***** IMPORTANT SAFETY RECALL *****
NHTSA Recall No. 18E-112
Cummins Campaign #C2101
Supplemental Notice: Updated Remedy

C2101 – Attachment B – ISV Secondary FEAD Upfit Instructions

Campaign Number: c2101	Revision: A	Released Date: 17-Jan-2020
ISV 5.0L Belt Slip Safety Campaign for Blue Bird Bus		Expiration Date (U.S. and Canada): 15-Jan-2045
		Expiration Date (International): 15-Jan-2045

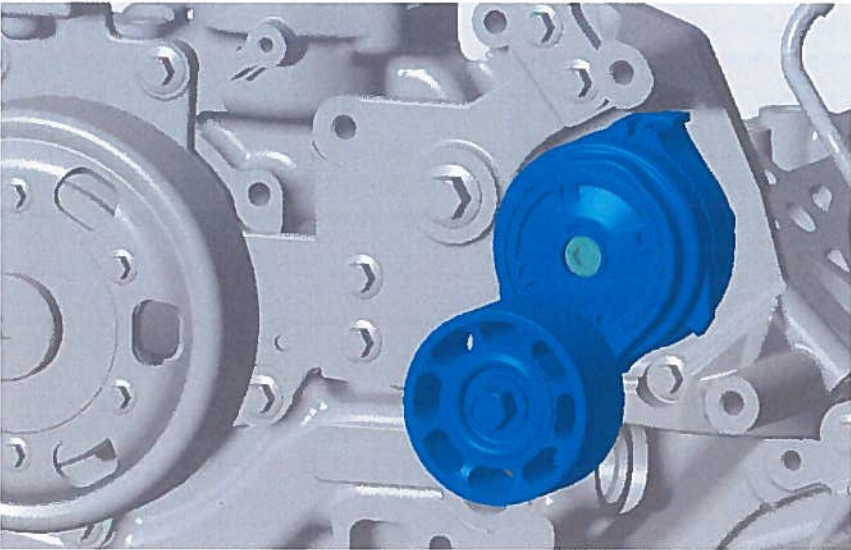
Install belt tensioner 4316721 using capcrew 4324939. Torque: 65 N-m [50 ft-lb]

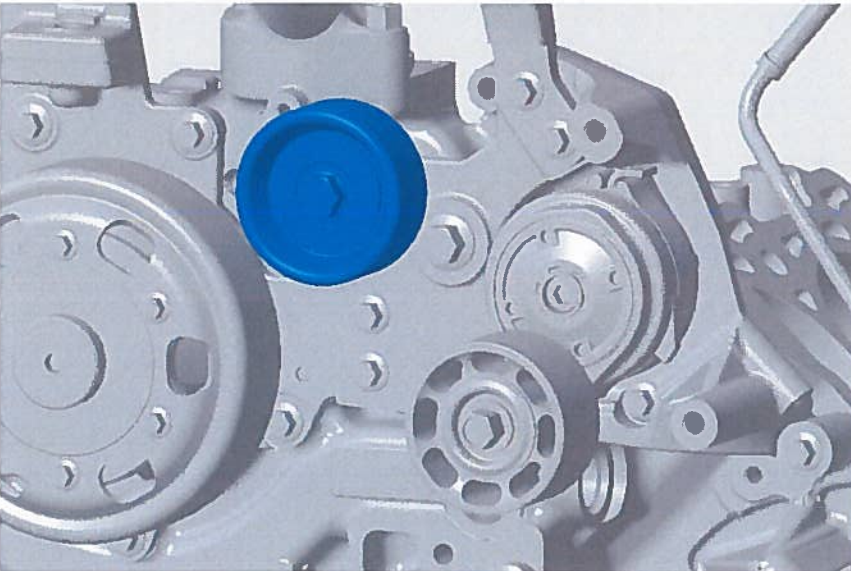
Install idler pulley assembly 4390737 (integrated capscrew). Torque: 34 N-m [25 ft-lb]

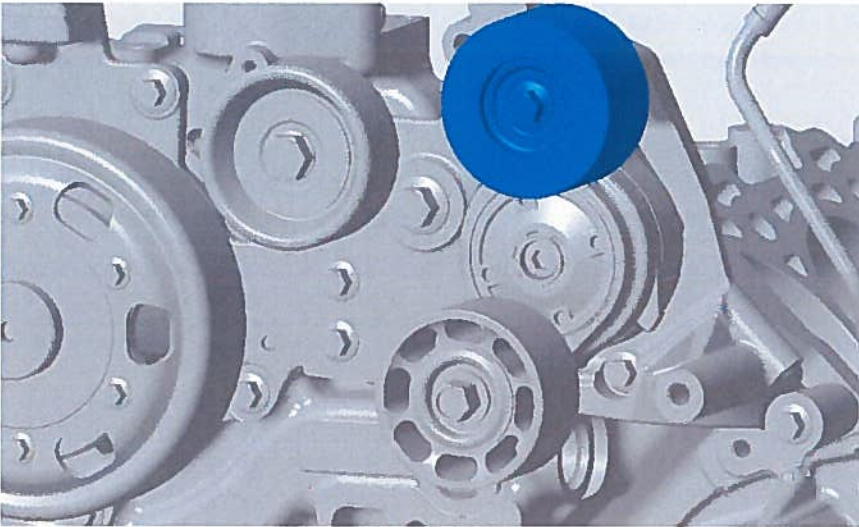
Install idler pulley assembly 5598353 (integrated capscrew). Torque: 65 N-m [50 ft-lb]

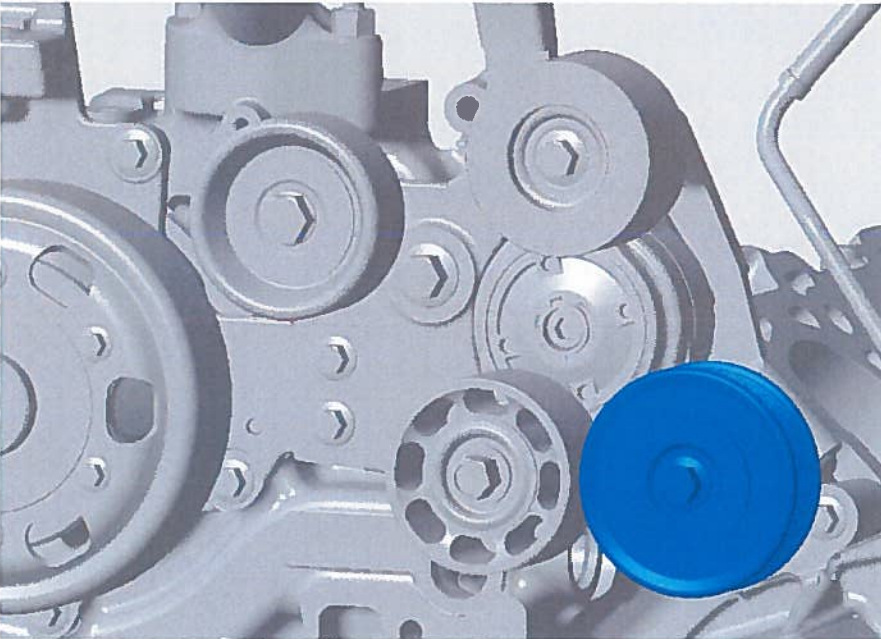
Install idler pulley assembly 5598324 (integrated capscrew). Torque: 65 N-m [50 ft-lb]

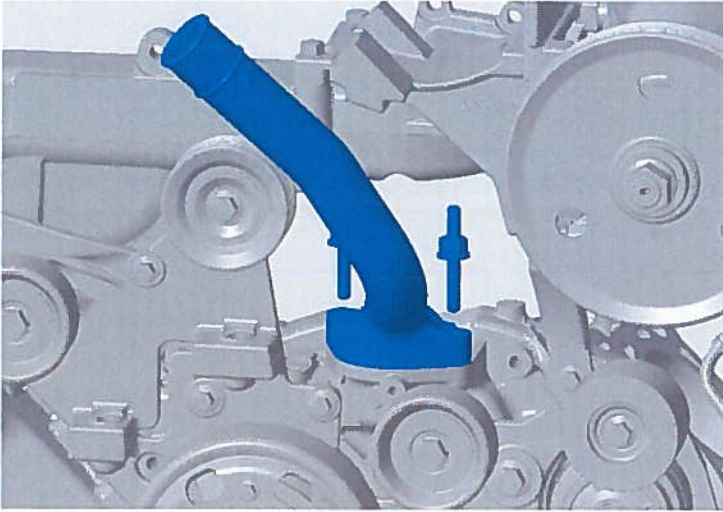
Intall thermostat into new thermostat housing 5414320. Install thermostat housing 5414320 as shown in the figure below. Use same capscrews 4325276. Refer to procedure 008-157-tr. Torque: 18 N-m [159 in-lb]

Remove 70 mm (2.75 in.) from engine side of hose

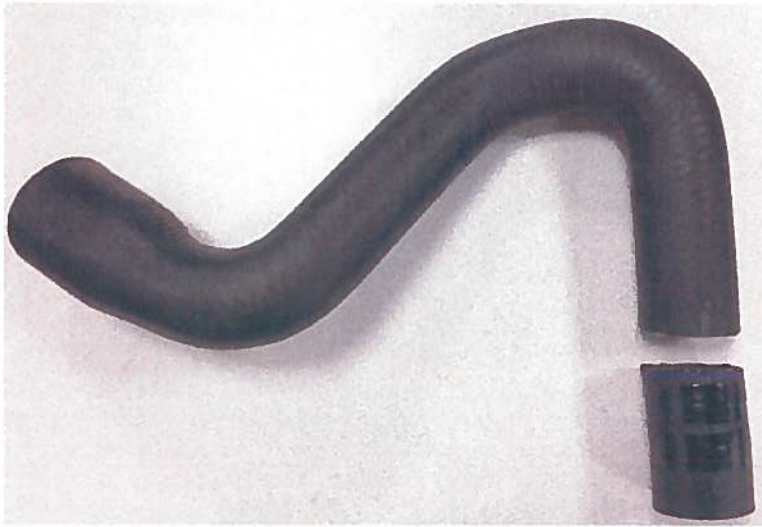
The coolant hose from the thermostat housing to the radiator must be modified to prevent kinking with the new design. Please follow the following steps to modify the coolant hose:

1. Remove the coolant hose from the vehicle.
2. Identify the end that connects to the thermostat housing (engine side). This will be the narrower end.
3. Mark 70 mm (2.75 in) from the end using a pen or marker.
4. Use a sharp utility knife to cut the hose. Try to cut the hose perpendicular to the edge. Make sure not to remove too much. More length can be removed if it does not fit properly.
